45.7007.R1/GA/DT/2015

Tony and Vilma Concato
87 Tallawong Road
ROUSE HILL NSW 2155

REVIEW OF ACOUSTIC PLANNING ISSUES
SYDNEY METRO NORTHWEST
RAPID TRANSIT RAIL FACILITY

Figure 4. Indicative Land Planning Map for Riverstone East

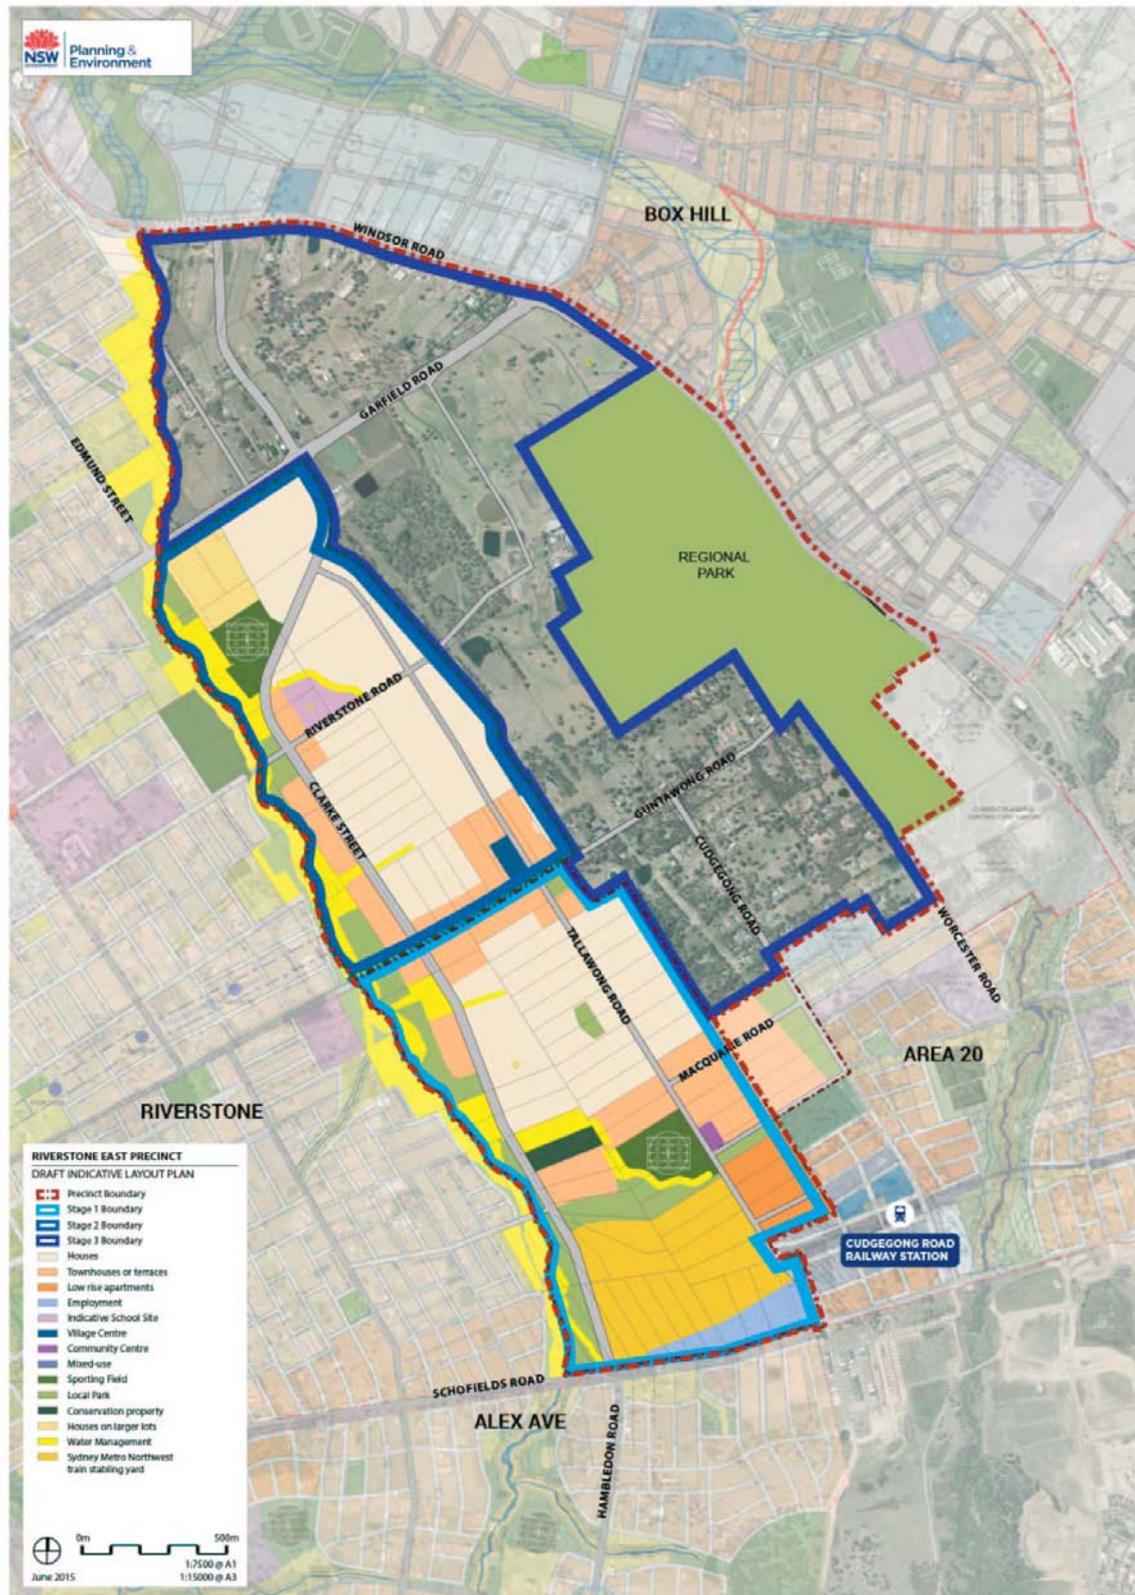
Tonin (Section 3) refers to the latest ILP (Figure 4) and reports that it has resulted in a reduction of potential land use conflicts, in particular through effective use of open

- in line with the recommendations of the EIS, zoning immediate surrounding the RTRF should consider less noise sensitive development such as commercial and light industrial zones; *NSW DoP has not adopted this recommendation in the ILP.*

- land to the south of the RTRF is zoned as a business park;
- land to the north and north-east does include residential development; *NSW DoP has in part adopted this recommendation in the ILP*

A review of the ILP identifies that the land immediate to the north of the RTRF is zoned 'local park', land further to the north is zoned 'sporting fields' and 'low rise apartment', the land to the east 'town houses and terraces'. From an acoustic view point, if noise impacts from the RTRF are to satisfy INP criteria for residential use at the 'town house and terraces' to the north and 'low rise apartments' to the east, noise at the Concato property (87 Tallawood Road) would satisfy the INP noise criteria for residential use, as it is located further away.

In addition to acoustic planning issues in our opinion no consideration has been given to noise impacts from the proposed 'sporting field' (*Figure 4*). A responsible planning issue that should be addressed is the envisaged activities, number of participants, number of spectators (supporter), hours of use, parking arrangement, etc and associated noise impacts.

From our investigations and review of the ILP, if land zoned for residential use is located closer to the RTRF than the property at 87 Tallawong Road, and noise at these properties is controlled to satisfy the requirements of the NSW INP, the land at 87 Tallawong Road is not required to provide a 'noise buffer zone' for nearby residential development and it would be suitable for residential development.
